ADDENDUM NO.: 3

DATE OF ADDENDUM: August 25, 2016

**New Police Facility for
Western Connecticut State University
Danbury, CT
BI – RD– 273**

*DOOR
 DETAILS
 H-9 AND
 J-9*

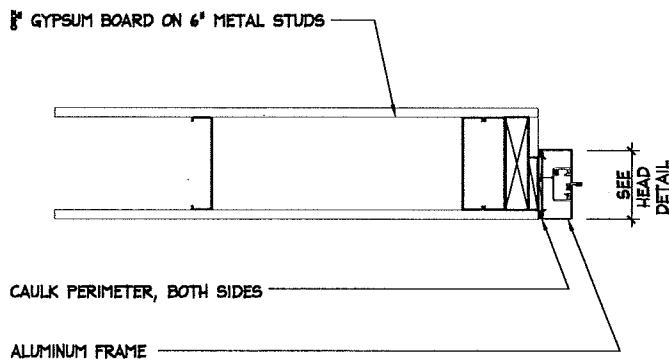
Contractor RFI: Ref. Specification Section 08 06 10. The Opening Schedule calls out head and jamb details H-8 and J-8 for interior aluminum frames 117A and 127A. These details appear to be for an overhead door

Answer: **Revise** details for openings 117A and 127A to be head detail H-9 and jamb detail J-9 as shown on attached sketch SK-1, dated 8-24-16.

*BICYCLE
RACK
INSTALLATION
DETAIL*

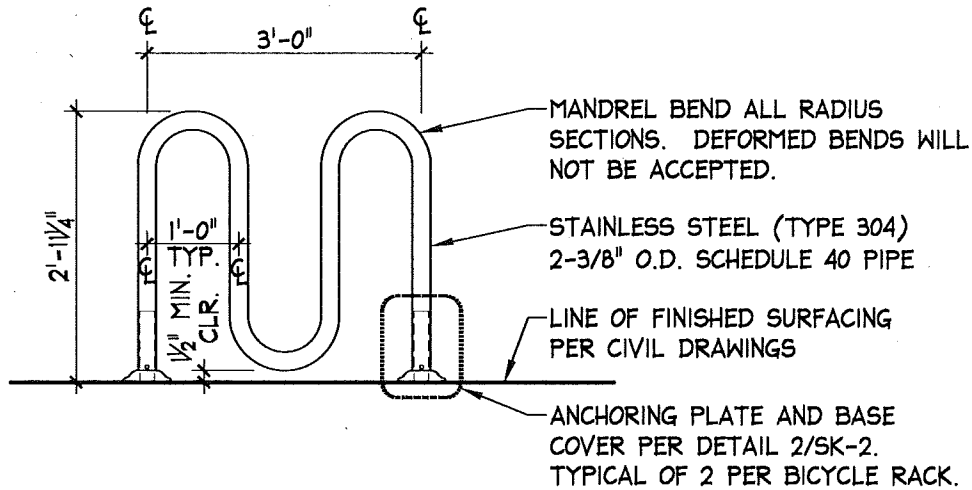
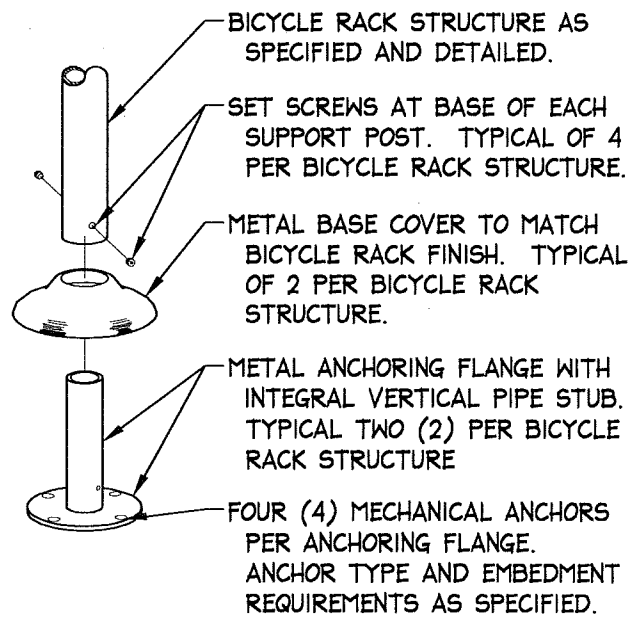
Contractor RFI: There is no detail depicting the concrete thickness or base thickness for the Bicycle Pad. Please clarify

Answer: See detail 10/C3.1 for concrete thickness and base thickness. Refer to detail 12/C3.1 for expansion and control joint locations. **ADD** specification section 12 93 13 Bicycle Racks. **ADD** sketch SK-2, dated 8-24-16 for bicycle rack detail.
